- Wiltshire councils SFRA which is the online arcgis, live version of the document has flooding maps that show the extent of flooding based on historic floods rather than modelled estimates.

- Despite the EA requiring a main modification in the current core strategy for Warminster that a SFRA 2 for the town be done due to the complex nature of flooding and the unknown interactions of various flood sources and topography, or the capacity and effectiveness of current flood management infrastructure to cope with current demands on it, let alone those increases due to climate change, this has not been done.

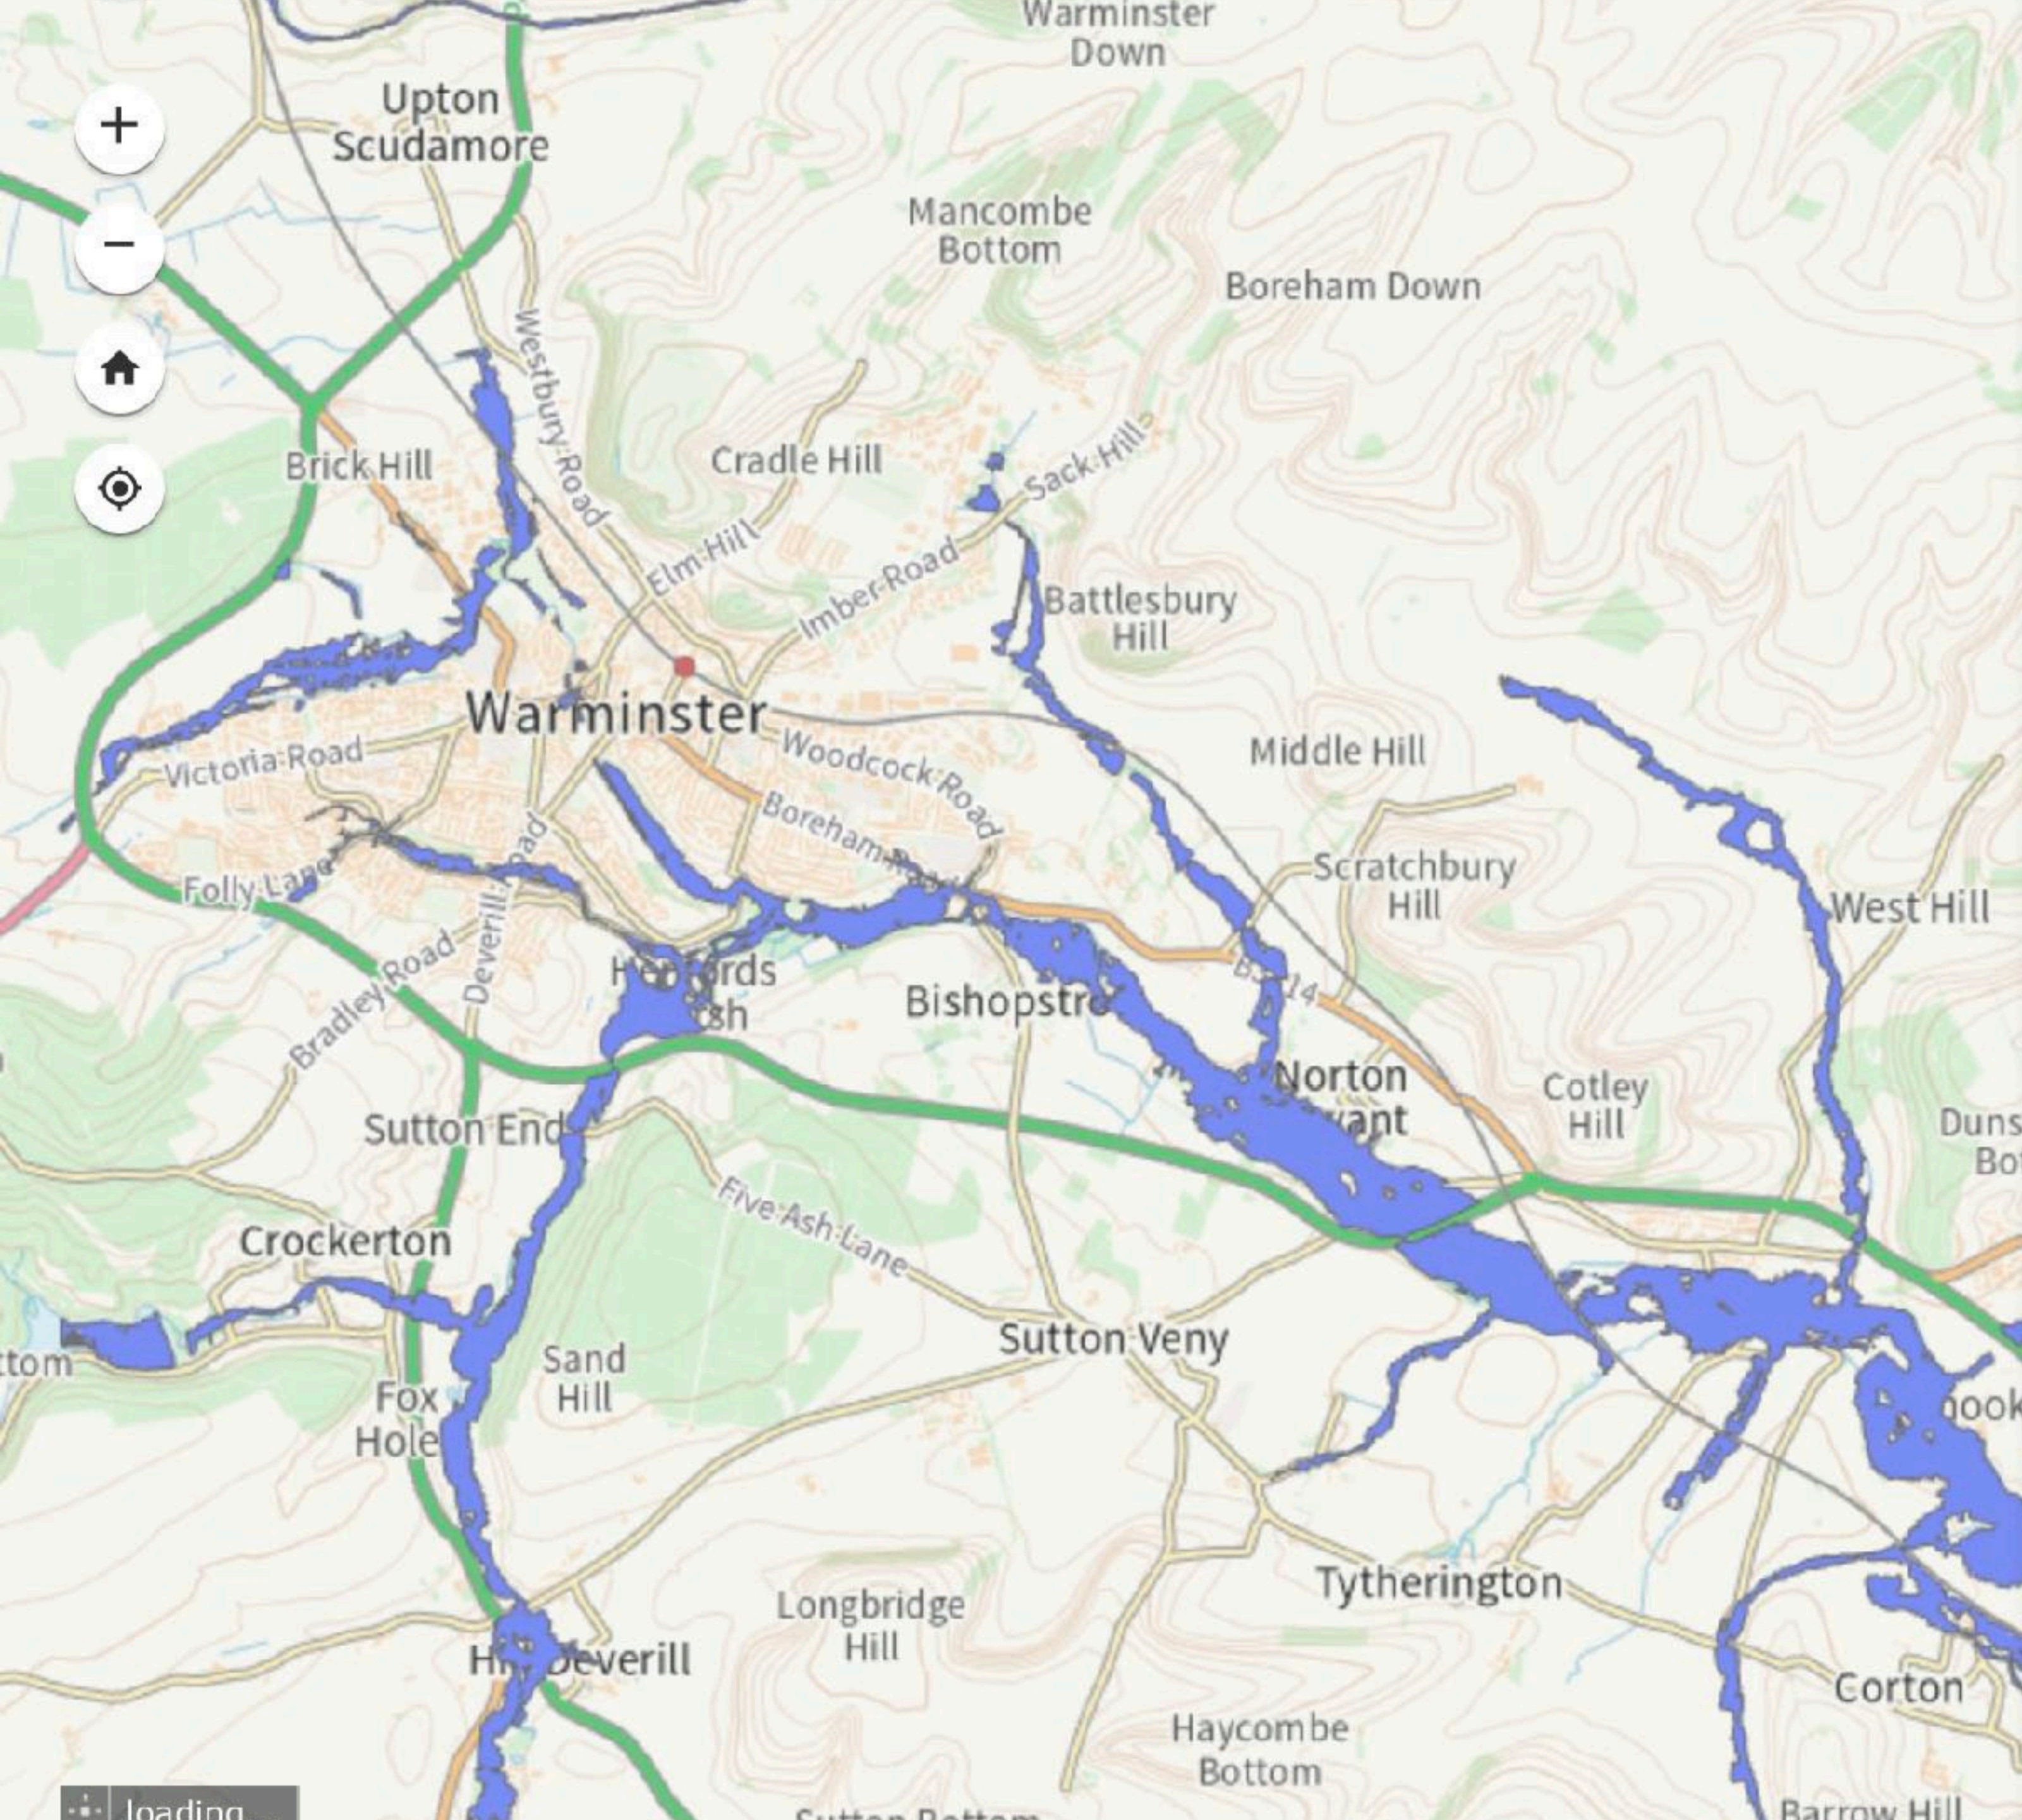
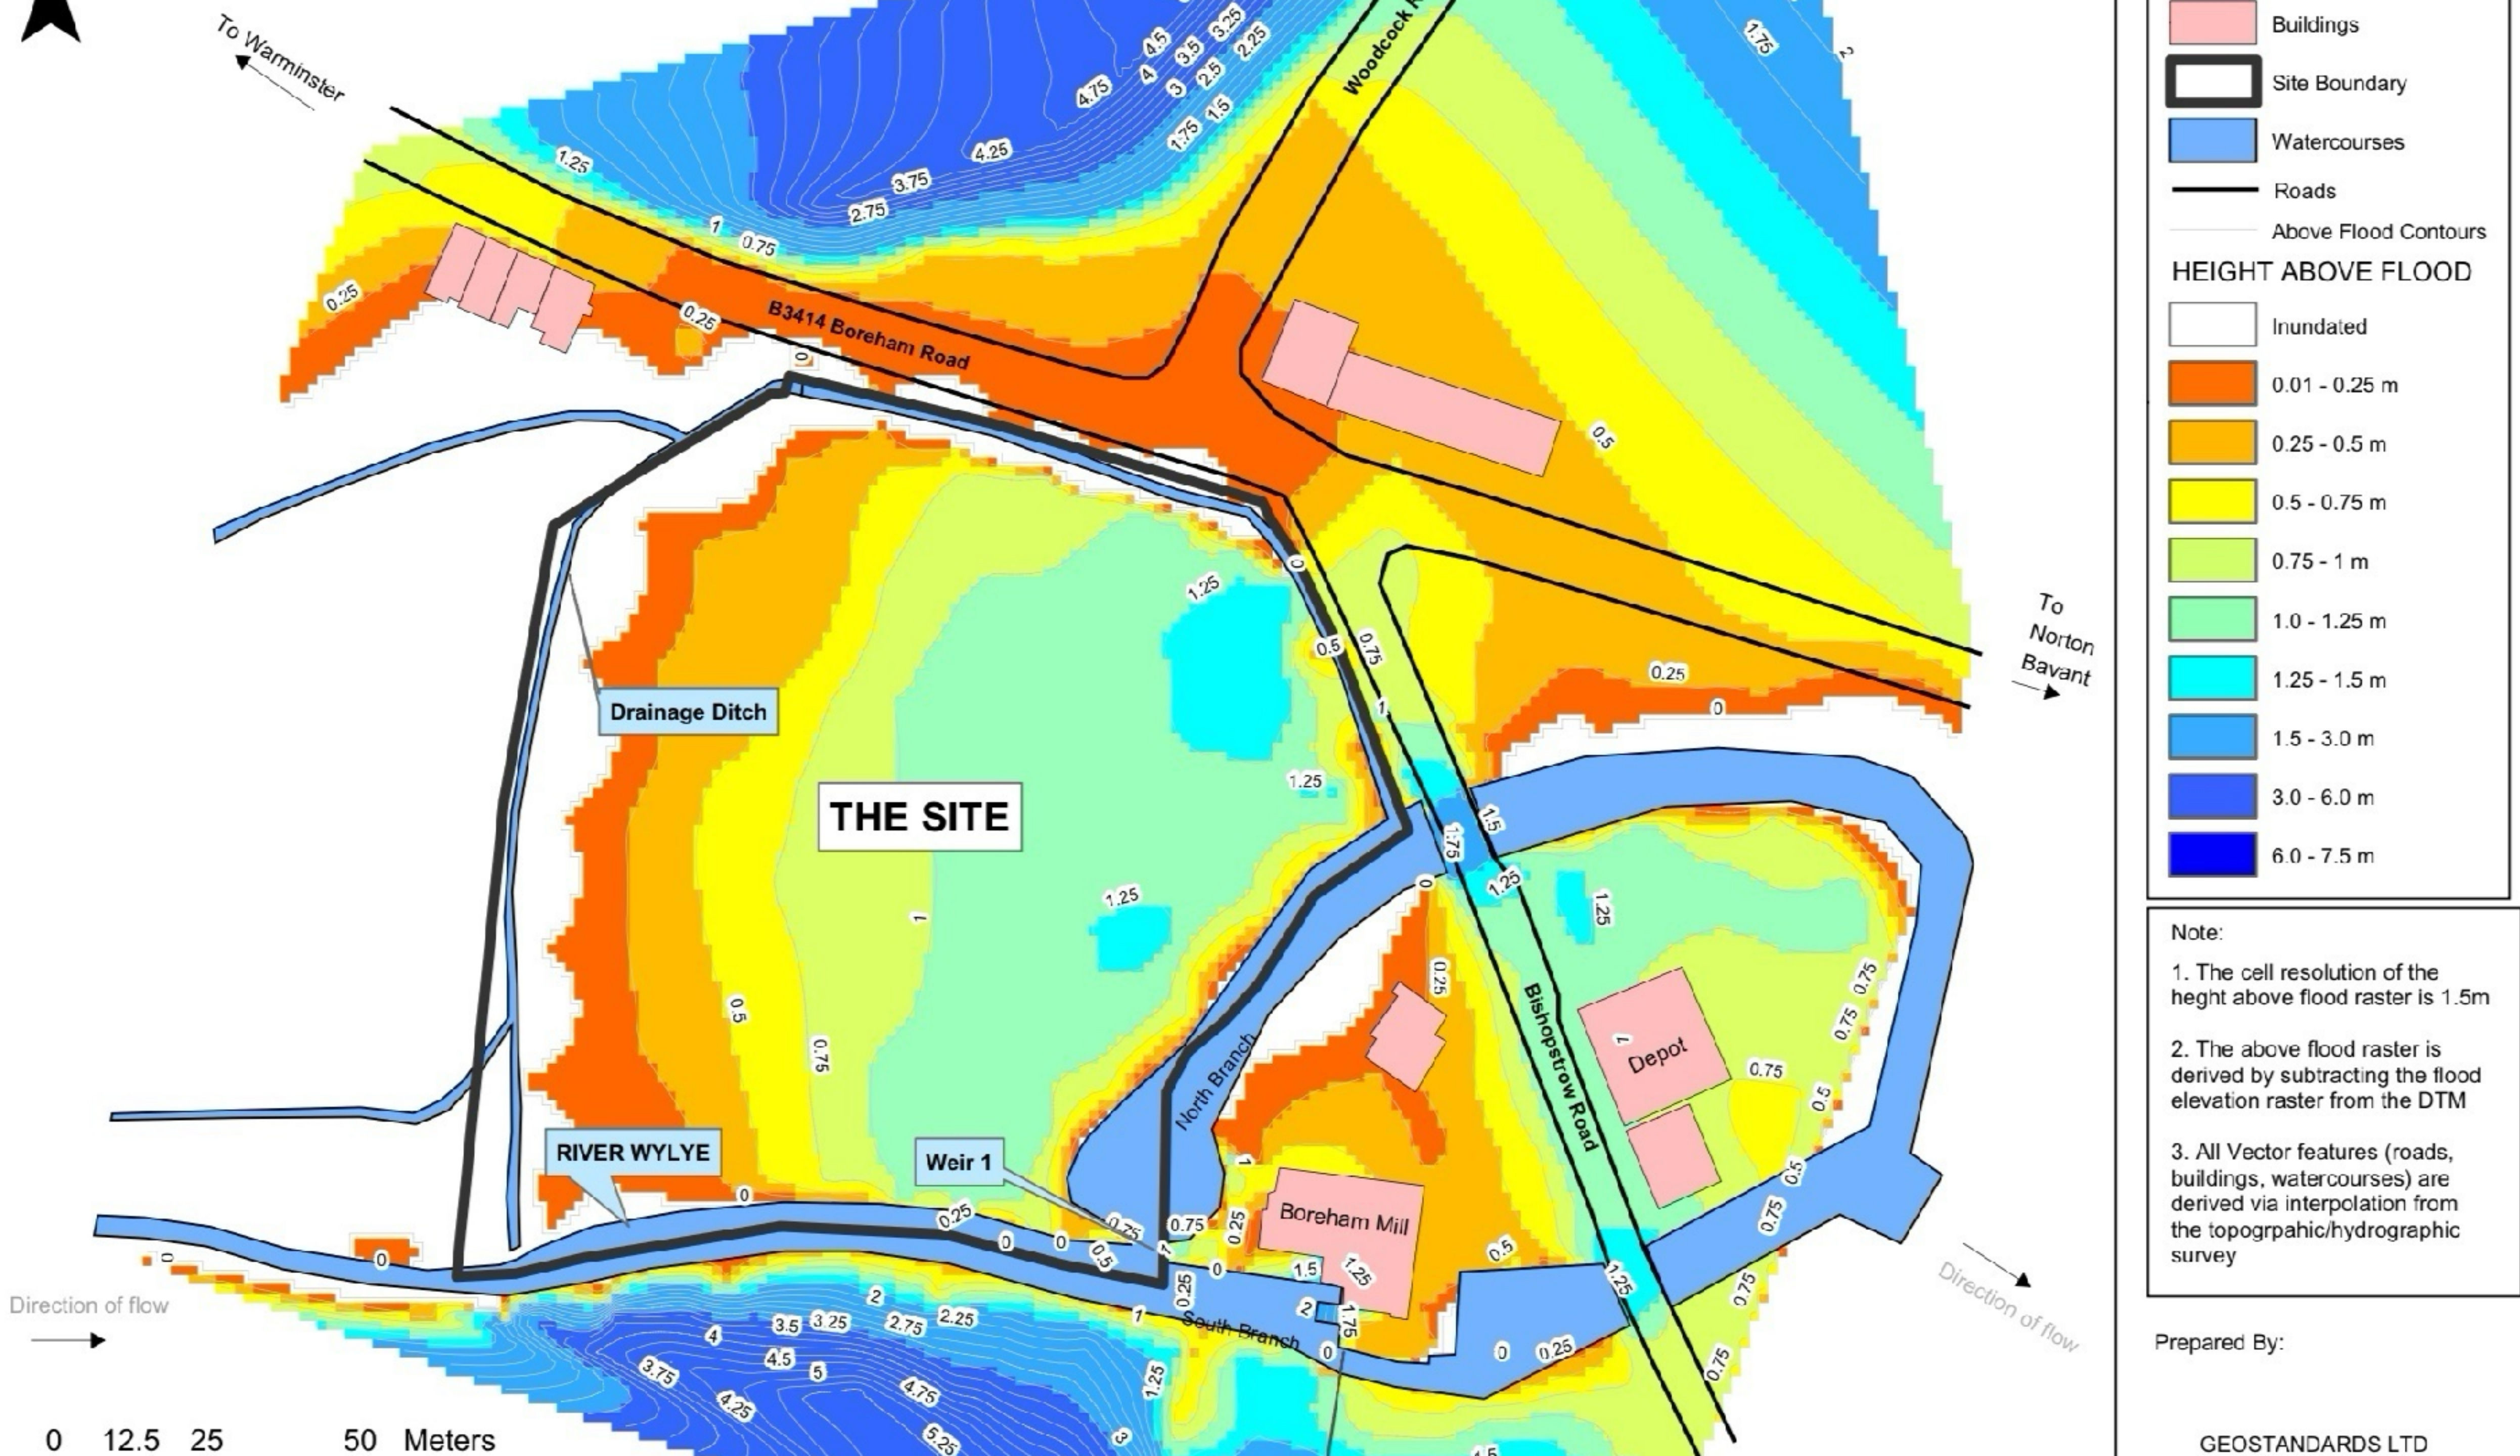
- The above map highlights the potential extent of hydrological models of river flooding, now showing Warminster is potentially as heavily impacted as Trowbridge, which would not have been apparent on the previous maps, and would infer that Warminster's rivers were so well managed that flooding never occurred, which is the opposite of the real situation.

- The two above maps show the massive increase in floodplain width as Water leaves Warminster and flows down the valley.
- It highlights the pinch point at Boreham rd, and indicates that woodcock rd is heavily effected by river flooding, despite it being on the other side of the valley from the river.
- This can only occur due to the hydrological pressure being created by the blockage in the floodplain known as Boreham mead. This site removed the entire width of the floodplains flood storage and instead created a several hectare embankment, redirecting flood water from the valley into surrounding roads and houses such as park cottages.
- Without this embankment at Boreham mead there would be insufficient water pressure for the water to leave the valley and flood the road.

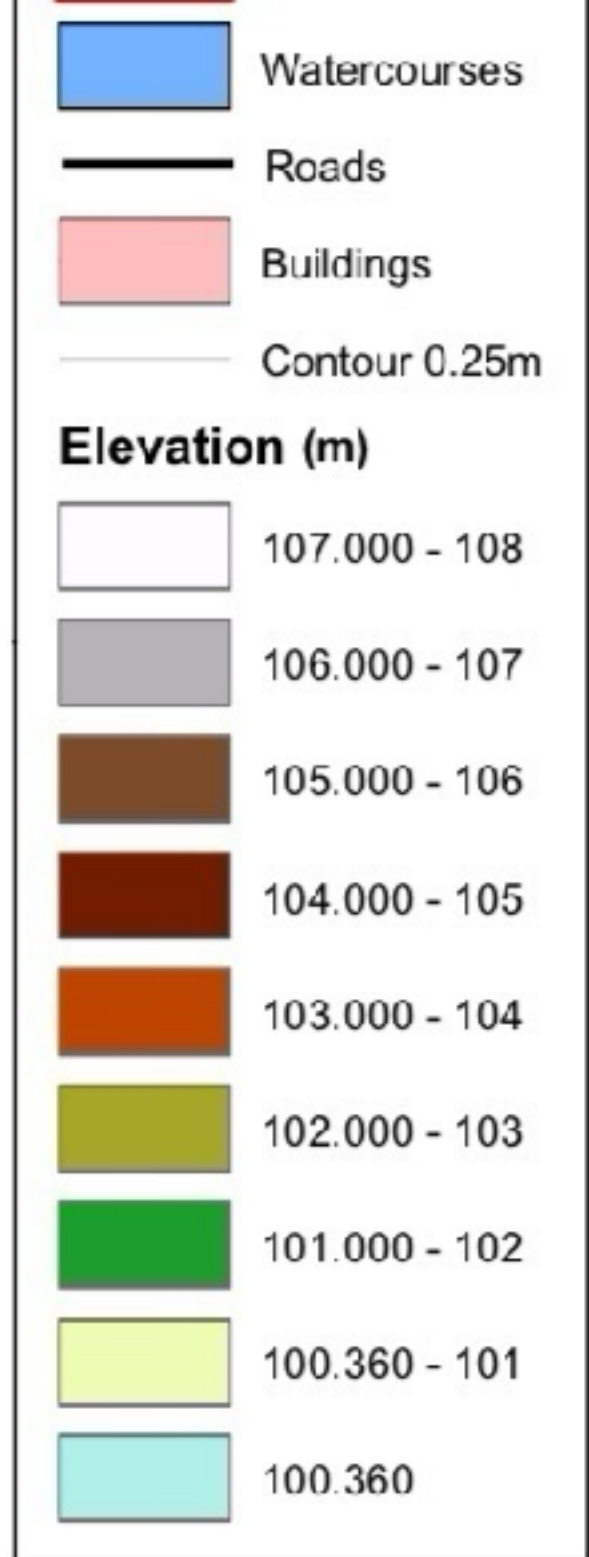
- The above map is a ground height map indicating height by colour. It shows the lowest point being the roundabout and woodcock /Boreham red junction to the back of the terrace. At this point the road rises and water from the river could only flow here under huge and continued pressure from water leaving the valley behind park cottages.

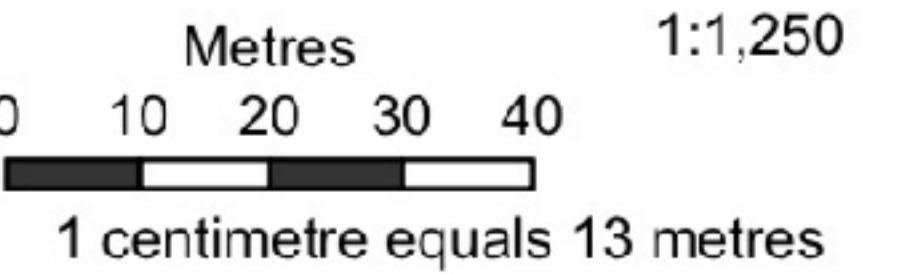
- The above map for Boreham mead is a less detailed version of the previous map, used by the developer in the attempt to change the flood map extent, which was Eventually successfully changed to show less of the site effected.

- This was the original EA flood extent map showing a large portion of the site being in zones 2-3. This flood extent map had prevented development of this site due to flood risk but once changed development could proceed.
- The EA allowed the hydrologists to use a permeable catchment figure for flood height, which lowers the extent as water is expected to drain freely, yet the EA knew the site is in a high ground water, flood warning area, which should have meant that the permeable nature of the site will increase flood risk due to high ground water in prolonged wet periods not reduce it, yet this was ignored and the map was changed allowing the developer to claim no development in zones 2-3 despite this being the case.
